BRIEF OPINION

**TEPCO PLAN TO FLOOD THE PRIMARY CONTAINMENT OF UNIT 1,
FUKUSHIMA DAI-ICHI**

CLIENT: GREENPEACE GERMANY

REPORT REF N° R3197-A1

FIGURE 2C CONTAINMENT FLOODING ARRANGEMENTS

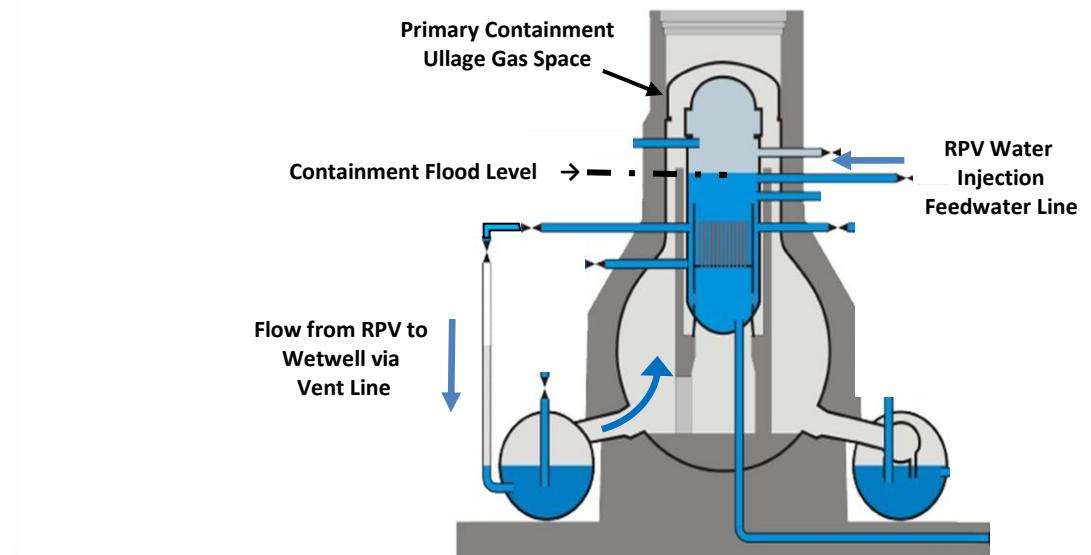
- According to the TEPCO flooding scheme,¹³ a link between the coolant in the RPV and the primary circuit is to be established – the coolant water injected into the RPV via the open feedwater line is to flow through and around the damaged fuel in the RPV, and then into the wetwell and drywell cavities.

- This arrangement means that a greater volume of water will be at risk of fission product contamination and release to the environment should the containment fail; and also

- the linking and flow arrangement removes the first containment barrier (the RPV) of what is presently a two-barrier containment system, that is reducing the enclosure to the single barrier of primary containment, which it has not been possible to inspect to determine its resilience against further seismic loading.
